Impact of Changes To Road Design (Asphalt Grindings and Road Cross-fall Audit)

Presented To:	Audit Committee	
Presented:	Tuesday, Aug 14, 2012	
Report Date	Wednesday, Aug 01, 2012	
Type:	Presentations

# IMPACT OF CHANGES TO ROAD DESIGN

Exhibit 4 - Lasalle Boulevard

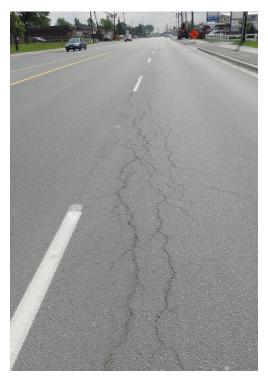
When the City does not receive quality of asphalt as designed, there is the risk to the City for premature failure of the asphalt which will lead to the need for future rehabilitation sooner than designed.

The City did identify the CIREAM concern and obtained an extension of the warranty for this section of Lasalle Blvd.

An independent third party has been retained to test and evaluate the reasons for this apparent "premature failure" of the road.

1) The City should improve policies, procedures and reports supporting accountability for rejection of inferior products and enhanced follow-up on warranty issues.

2) The City should further investigate rejectable materials from previous and current projects, and establish appropriate remedies where warranty provisions allow.
